The prospective bidders have raised the following questions regarding the bid documents and the responses to those questions are as follows.

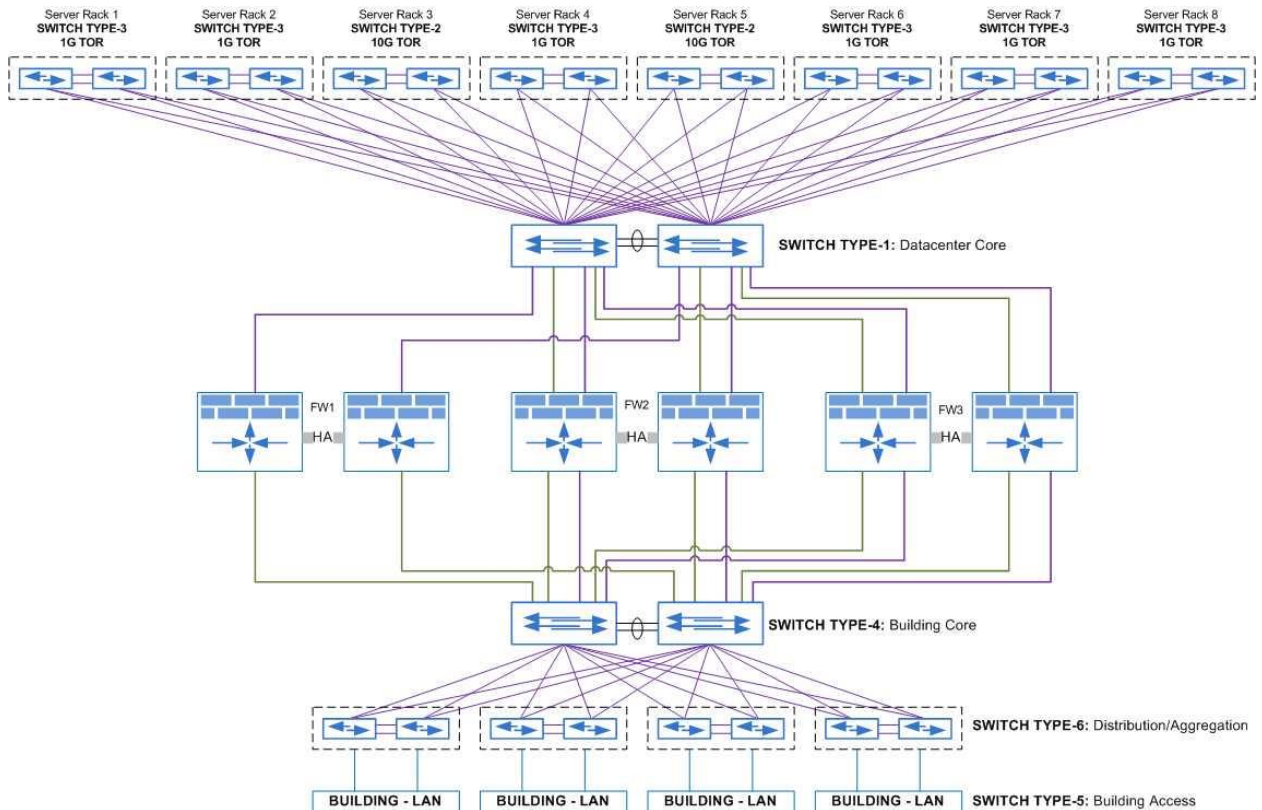
ANSWER: **Please provide the cables as per the bidding document specifications.**
5. Any network diagram/ topology can be provided for these switches?

6. We would appreciate if the Bank can share the Network Connectivity Diagram for this requirement in order for us to better understand this requirement to propose the best solution for the Bank.

ANSWER: **Please refer the diagram under question 5**
